**NOTICE OF ADDENDUM
ADDENDUM NO. 1**

**CONTRACT NO. 8312, PROJECT NO. 11871
SOUTH POINT ROAD ASSESSMENT DISTRICT – 2019**

INSTALL GLACIAL FIELD STONE
& GEOTEXTILE FILTER FABRIC
AT THREE 42\"/>

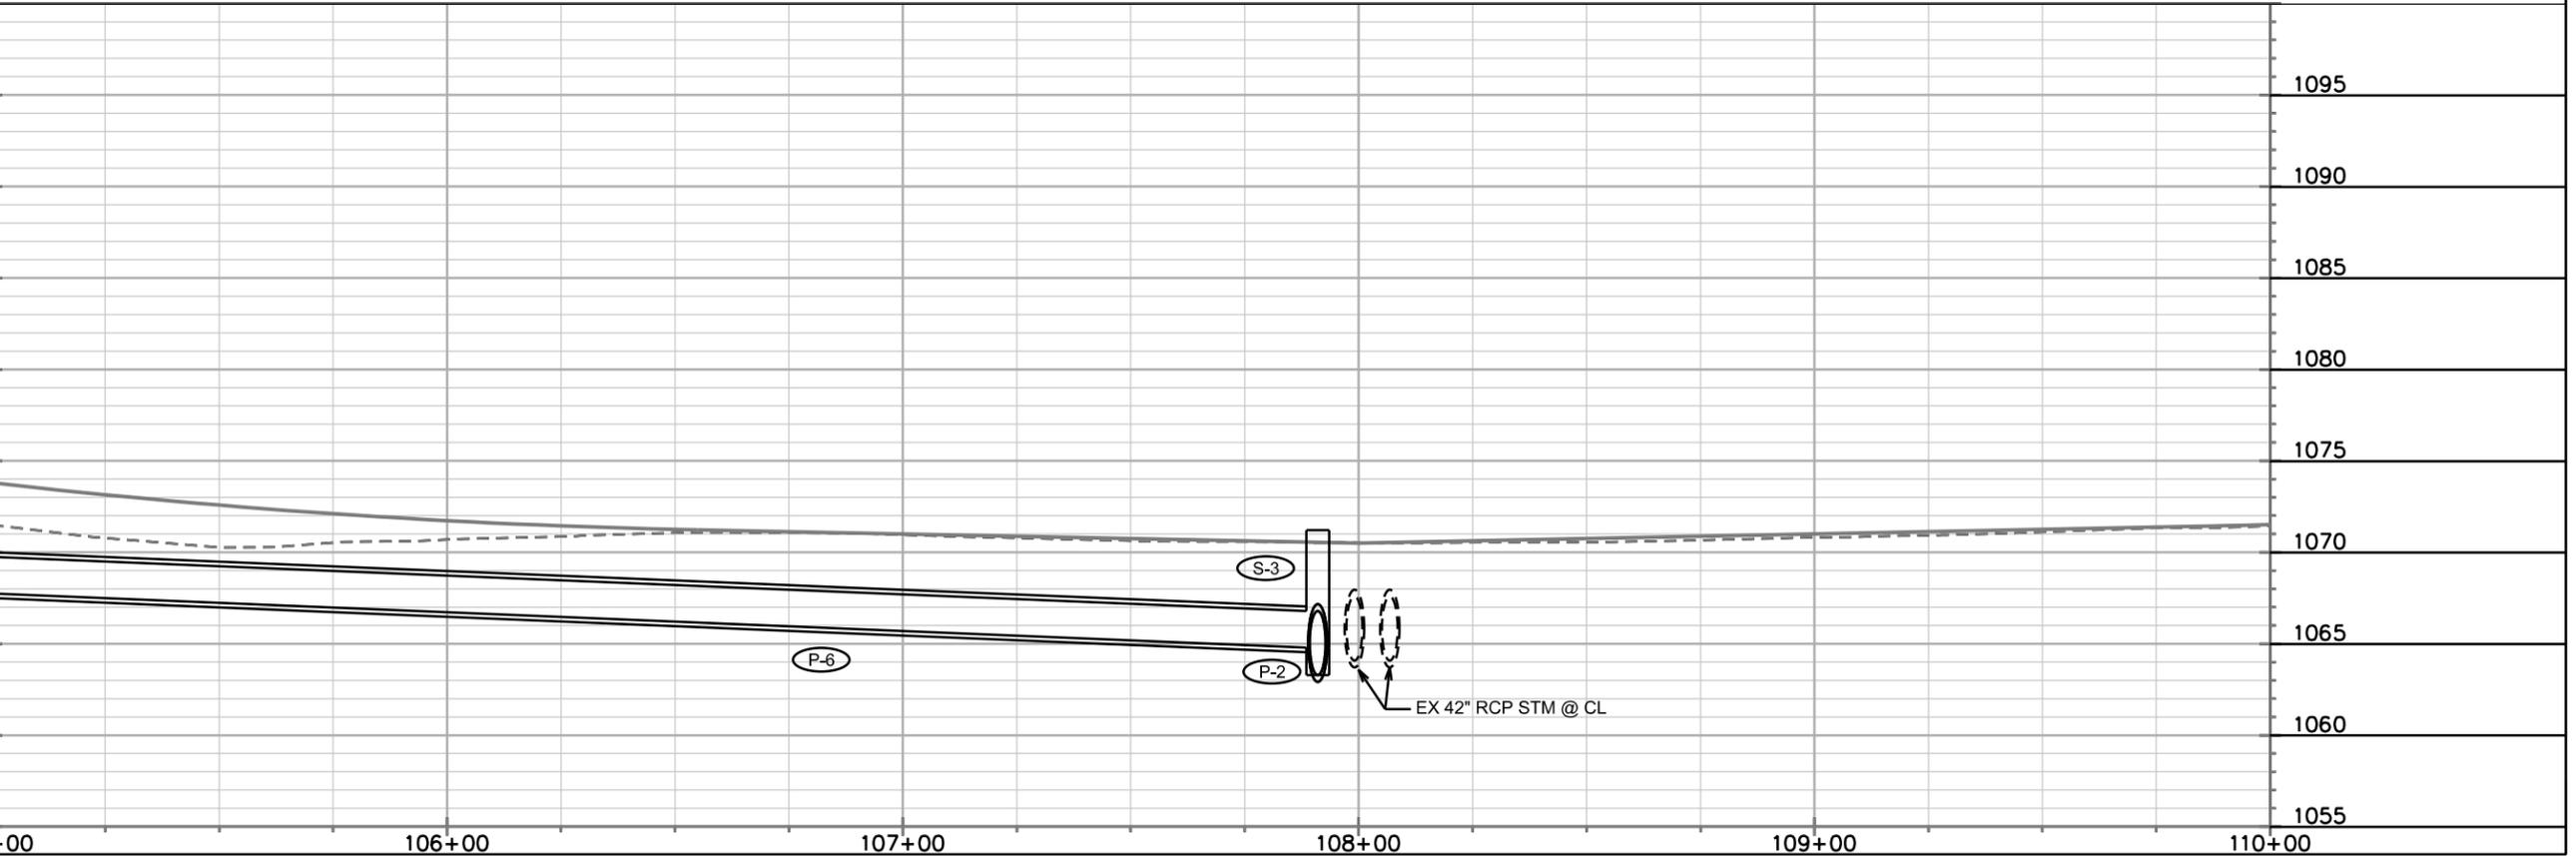
Insert Sheet U-3 (Revised 6-4-19)

Heavy riprap and filter fabric added to front of culvert apron ends.

Work under this item includes all equipment, materials, labor, and incidentals required to provide and install glacial field stone as shown in the plan set at the three (3) 42” apron endwalls at the west side of South Point Rd and described in these Special Provisions. The stone shall be sized and placed in accordance with Article 212 of the Standard Specifications. All riprap shall be underlain with Geotextile Filter Fabric Type HR, which will be paid for under Bid Item 20233.

Filter fabric shall be placed in a manner that prevents excess material from showing beyond the placed riprap. Riprap shall be placed such that the top surface of the stone is at or below the apron endwall elevation.
